**UNIFORM STANDARD DRAWINGS  
CLARK COUNTY AREA, NEVADA**

**YEAR 2017 REVISIONS**

LOUVERED BACKPLATE FOR  
POLE MOUNTED SIGNAL

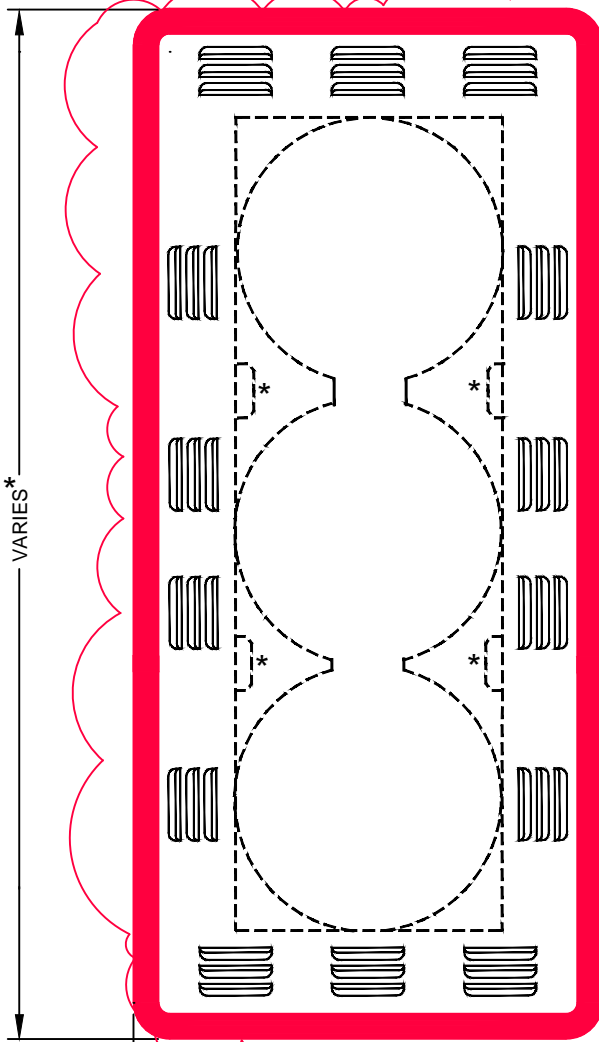
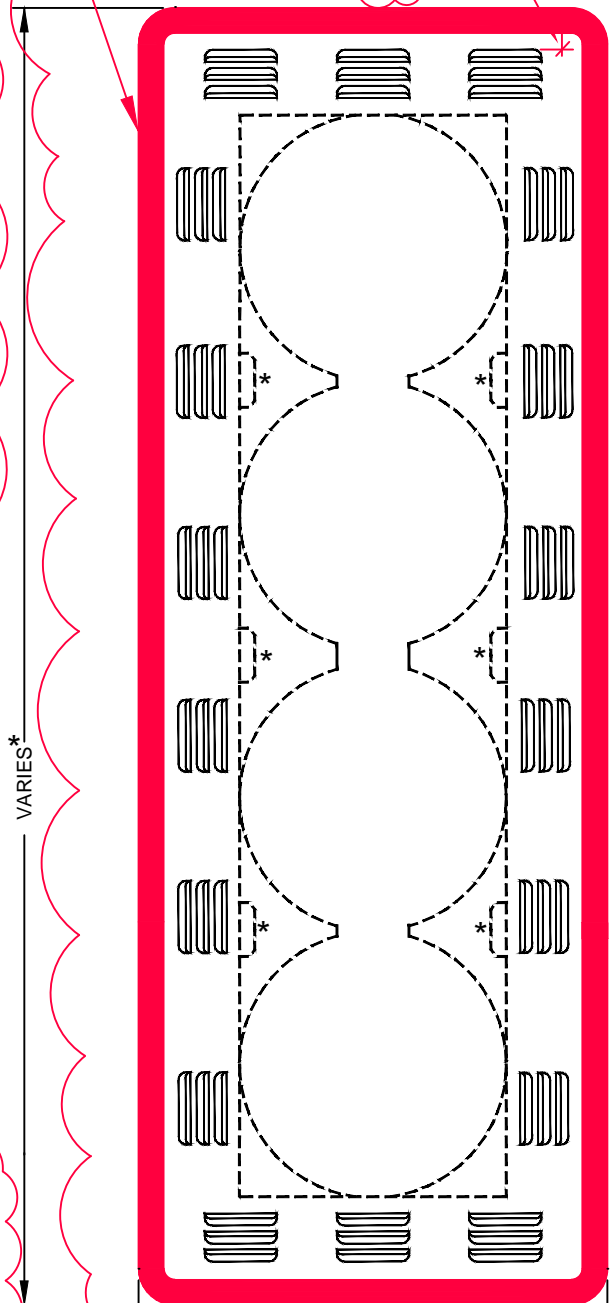
840	"Louvered Backplate for Mast Arm Mounted Signal" – Drawing revised to add the requirement for retroreflective traffic signal backplates.	7/1/2017
841	"Louvered Backplate for Pole Mounted Signal" – Drawing revised to add the requirement for retroreflective traffic signal backplates.	7/1/2017

2" YELLOW RETROREFLECTIVE BORDER LINE ADHESIVE SHEETING

1. ALL TRAFFIC SIGNAL BACKPLATES SHALL HAVE A 2-INCH RETROREFLECTIVE ADHESIVE SHEETING BORDER ON THE ENTIRE OUTER PERIMETER OF THE FRONT SIDE OF THE BACKPLATE.
2. RETROREFLECTIVE SHEETING SHALL BE FLUORESCENT YELLOW, ASTM D4956-13 TYPE XI OR BETTER.
3. THE RETROREFLECTIVE SHEETING BORDER SHALL HAVE A MINIMUM OF 0.5" CLEARANCE FROM ALL LOUVERS. NO RETROREFLECTIVE SHEETING SHALL BE PLACED OVER ANY LOUVERED AREA.
4. RETROREFLECTIVE SHEETING BORDER SHALL BE INSTALLED BY THE MANUFACTURER, AND MODIFICATIONS SHALL NOT BE MADE BY THE CONTRACTOR.
5. THE BACK PLATE WITH RETROREFLECTIVE SHEETING BORDER SHALL BE FROM THE SAME MANUFACTURER AS THE SIGNAL HEAD ASSEMBLY. THE COMPLETE HEAD ASSEMBLY, INCLUDING THE BACKPLATE, SHALL BE CAPABLE OF WITHSTANDING WINDS OF 90 MPH WITHOUT DAMAGE OR SEPARATION OF ANY PARTS FROM THE SIGNAL HEAD ASSEMBLY.

AGENCY APPROVED	B	C	H	L	M	N
UNIFORM STANDARD DRAWINGS CLARK COUNTY AREA						
LOUVERED BACKPLATE FOR 5 SECTION SIGNAL HEAD						
DATE 07-01-17	DWG. NO.	842	SHEET 1 OF 2

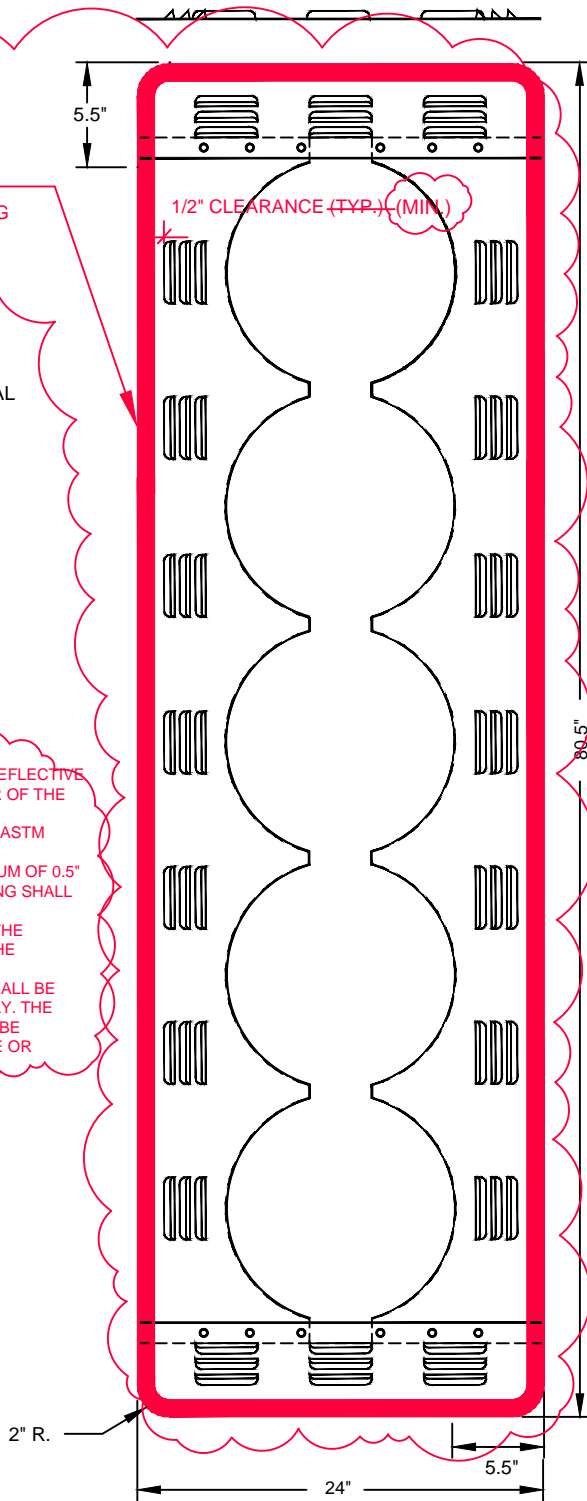
842.1	"Louvered Backplate for 5 Section Signal Head" – Drawing revised to add the requirement for retroreflective traffic signal backplates.	7/1/2017

2" YELLOW RETROREFLECTIVE  
BORDER LINE ADHESIVE SHEETING

1. ALL TRAFFIC SIGNAL BACKPLATES SHALL HAVE A 2-INCH RETROREFLECTIVE ADHESIVE SHEETING BORDER ON THE ENTIRE OUTER PERIMETER OF THE FRONT SIDE OF THE BACKPLATE.
2. RETROREFLECTIVE SHEETING SHALL BE FLUORESCENT YELLOW, ASTM D4956-13 TYPE XI OR BETTER.
3. THE RETROREFLECTIVE SHEETING BORDER SHALL HAVE A MINIMUM OF 0.5" CLEARANCE FROM ALL LOUVERS. NO RETROREFLECTIVE SHEETING SHALL BE PLACED OVER ANY LOUVERED AREA.
4. RETROREFLECTIVE SHEETING BORDER SHALL BE INSTALLED BY THE MANUFACTURER, AND MODIFICATIONS SHALL NOT BE MADE BY THE CONTRACTOR.
5. THE BACK PLATE WITH RETROREFLECTIVE SHEETING BORDER SHALL BE FROM THE SAME MANUFACTURER AS THE SIGNAL HEAD ASSEMBLY. THE COMPLETE HEAD ASSEMBLY, INCLUDING THE BACKPLATE, SHALL BE CAPABLE OF WITHSTANDING WINDS OF 90 MPH WITHOUT DAMAGE OR SEPARATION OF ANY PARTS FROM THE SIGNAL HEAD ASSEMBLY.
